Informal document GRB-64-01
(64th GRB, 5-7 September 2016,
agenda item 2)

Proposal for Supplement 5 to Regulation No. 28

The text reproduced below was prepared by the expert from the Russian Federation in addition to ECE/TRANS/WP.29/GRB/2016/4. It contains a number of comments to clarify the modifications made to the previous proposal in ECE/TRANS/WP.29/GRB/2016/2. The proposed amendments to the current Regulation are marked in bold for new or strikethrough for deleted characters.

Figure 1 (All dimensions are in m)

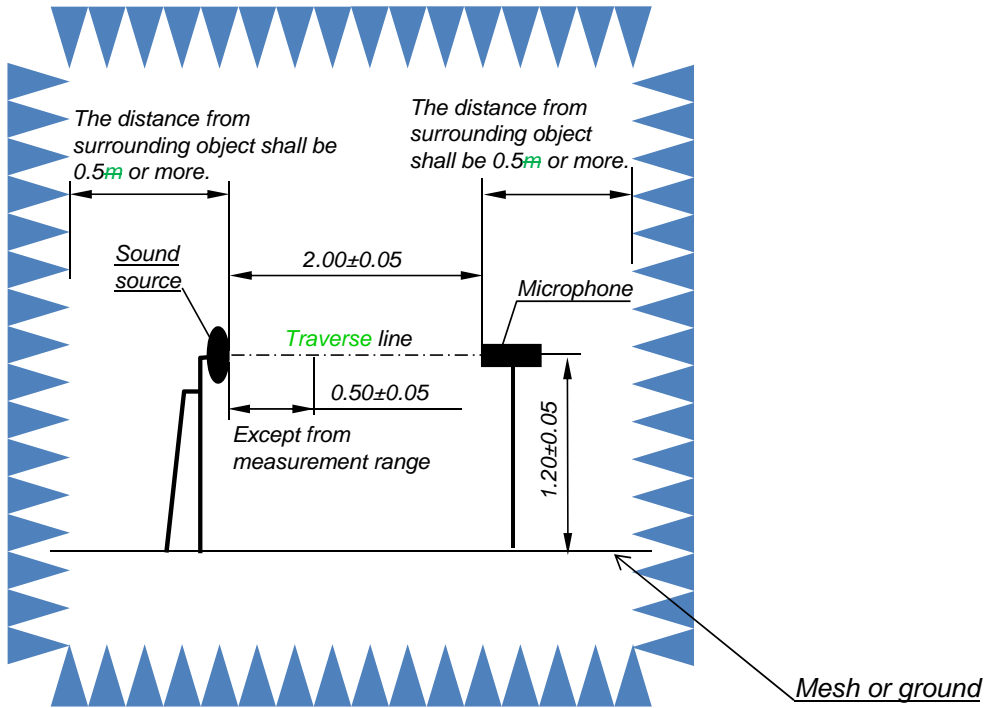
- A minimum of 10 points shall be used for evaluation on the microphone traverse line. The measurement shall start at $0,5 \pm 0,05$ m from the sound source, and spacing shall be ~~15 cm~~**0.15m** (e.g. ~~Figure~~ **Figure 1**).

A. In case of an audible warning device

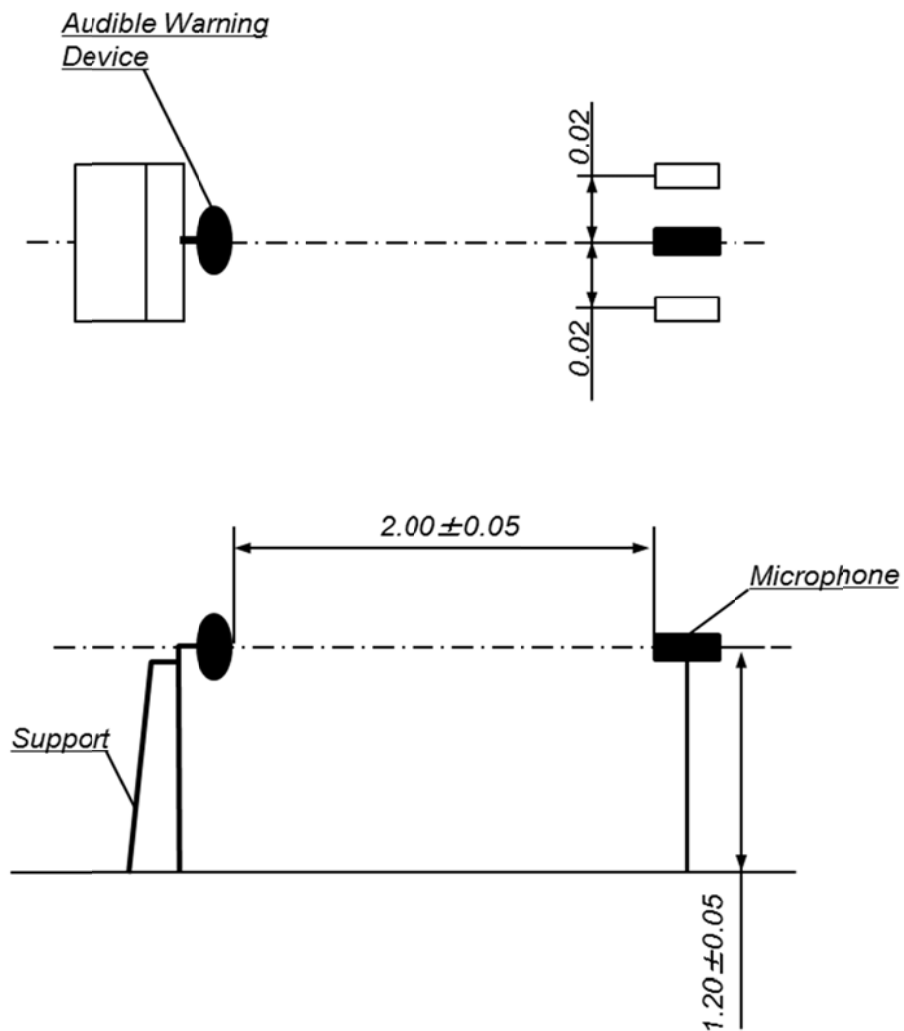
The microphone shall be so placed that its diaphragm is at a distance of 2.00 ± 0.04 0.05 m from the plane of the sound outlet of the audible warning device. The microphone must be positioned facing the front surface emitting sound of the audible warning device, audible warning system or multiple audible warning system in the direction in which the maximum sound level can be measured. See figure in Annex 4.

13. The text provides for clarification on the positioning of the measuring microphone during the tests. The reference to the Annex 4 is added.

B. In case of audible warning system and multiple audible warning system

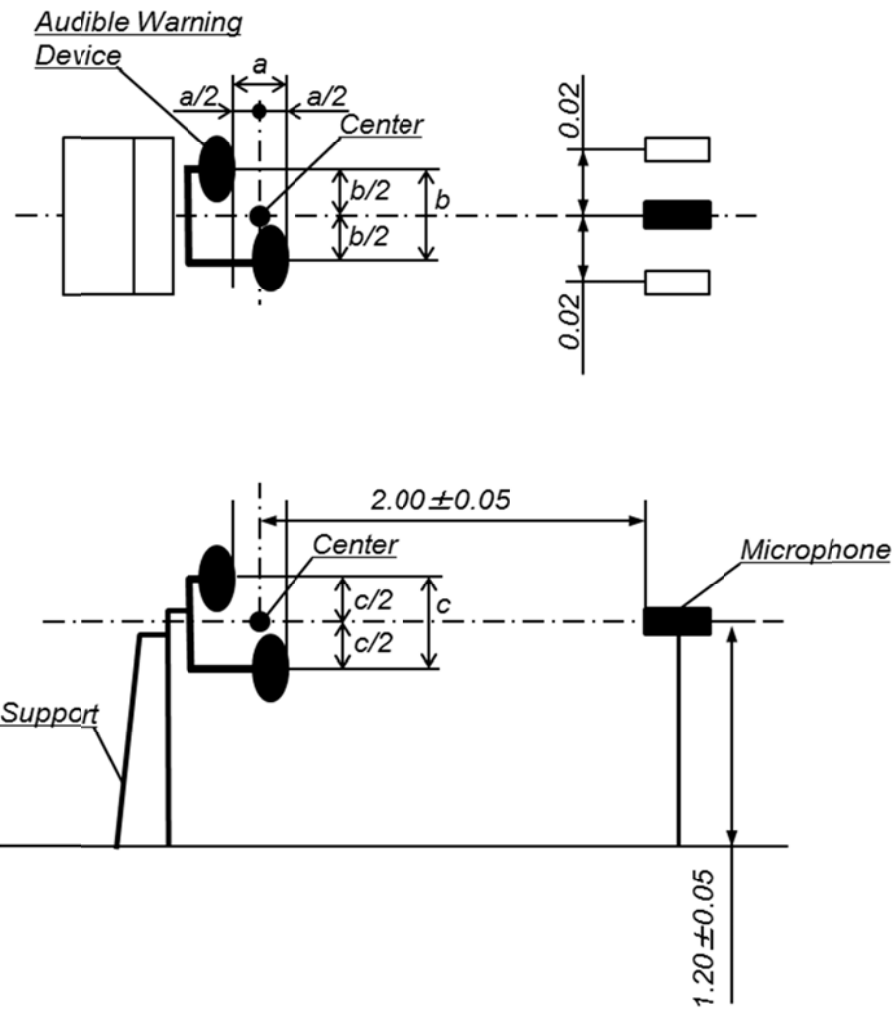
Comment [549]: Part B was added as proposed by Japan.

The reference point is the centre of a figure connecting the sound emitting opening centre of each audible warning device.

Microphone positions for measurements of audible warning signals of motor vehicles

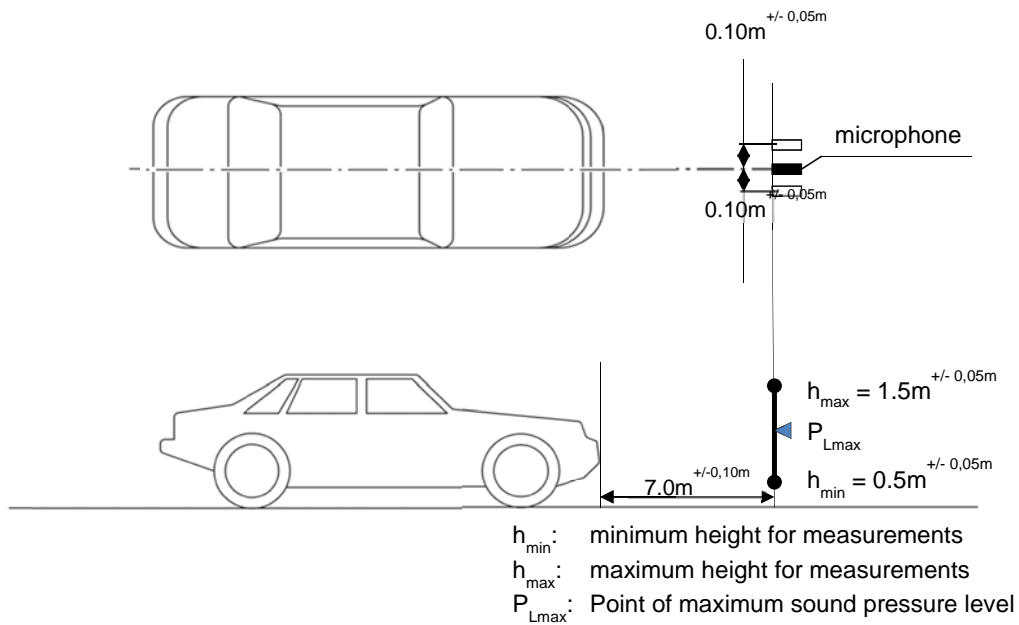
Comment [B50]: The drawing changed to the one from GRB-63-04 (Russian Federation)
